Access Compliance Report

Public Rights-of-Way

(Curb Ramps)

Intersection ID: 47684	Main Street: NEWFIELD_ST	Cross Street: LEWISBURG_ST	Location: S
ADA ID: 957C996F72A0	Ramp Type: BlendTrans1	Initial Pass/Fail: Fail	Overall Compliance: No
		Severity Score: 8.75

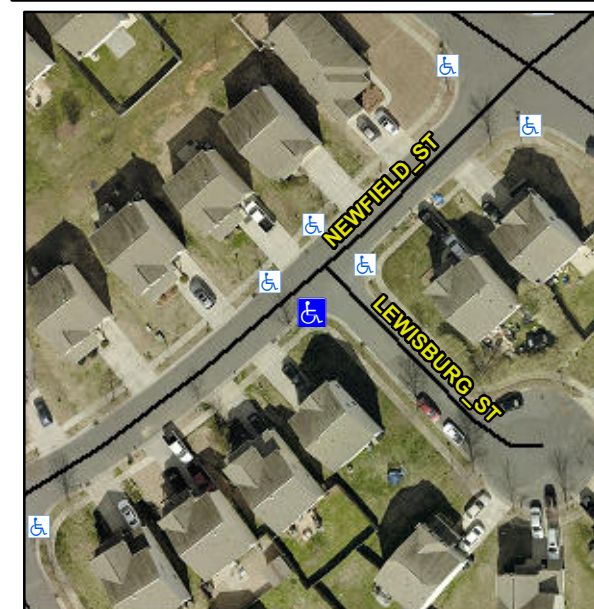
Compliance	Description	Data	Compliance	Description	Data
N/A	Ramp Length (in)	49.0	Yes	BlendTrans Slope (%)	4.7
No	Ramp Width (in)	47.5	Yes	BlendTrans XSlope (%)	0.8
N/A	Flare Type LT	N/A	N/A	Flare Type RT	N/A
N/A	Flare Slope LT (%)	N/A	N/A	Flare Slope RT (%)	N/A
N/A	Flare Traversable LT?	N/A	N/A	Flare Traversable RT?	N/A
N/A	Landing Length (in)	N/A	N/A	DWS Provided?	N/A
N/A	Landing Width (in)	N/A	N/A	DWS Contrast?	N/A
N/A	Landing Slope (%)	N/A	N/A	DWS Length (in)	N/A
N/A	Landing X Slope (%)	N/A	N/A	DWS Full Width?	N/A
N/A	Landing Curb? (Y/N)	N/A	N/A	DWS Offset (in)	N/A
N/A	Shared Landing?	N/A			
N/A	Gutter Ponding?	N/A	N/A	Gutter Slope (%)	N/A
N/A	Gutter Lip Ht (in)	N/A	N/A	Gutter X Slope (%)	N/A
N/A	Painted X Walk1?	No	N/A	Painted X Walk2?	No
	X Walk 1 Direction	To NE		X Walk 2 Direction	To NW
	X Walk 1 Width (in)	N/A		X Walk 2 Width (in)	N/A
	X Walk 1 Slope (%)	3.0		X Walk 2 Slope (%)	1.6
	X Walk 1 X Slope (%)	0.8		X Walk 2 X Slope (%)	1.9

N/A	Ramp inside XWalk1?	N/A	N/A	Ramp inside XWalk2?	N/A
	Road Slope (%)	2.1		Clear Space?	N/A
	Road X Slope (%)	0.5	N/A	Clear Space to XWalk (in)	N/A
N/A	Any Obstructions?	N/A	N/A	Storm Grate/Utility Hazard?	N/A
	Obstruction Type			Storm Grate/Utility Type	
		N/A			N/A
			Yes	Surface Condition? (G/P)	Good
			N/A	Curb Slope (%)	3.9

Remove & Replace Curb Ramp With Two New Directional Ramps or Equivalent.

R304.5.1
